PRODUCT/PROCESS CHANGE NOTICE (PCN)

ATTACHMENT I - PCN #: TB1504-01 (R1)

PCN Type: Packaging

Figure 1: Additional Label pasted on ESD/Moisture barrier bag and Pizza box

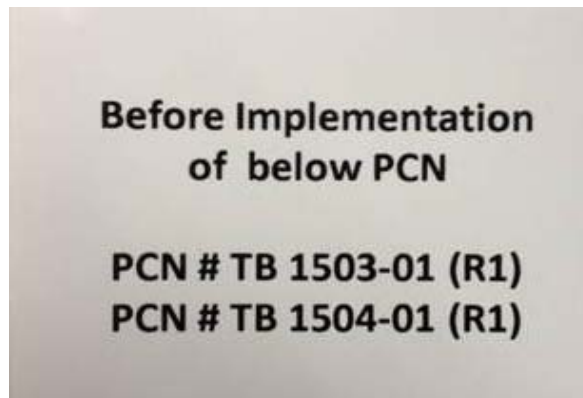
Customers may expect to receive shipments of products in new packing no sooner than 90 days from the date of this PCN notification. Shipments to customers may contain products shipped with either the existing packing or new packing during the transition period. Shipments made in the existing packing after the PCN becomes effective will have an additional label pasted on the ESD/moisture barrier bag and pizza box.
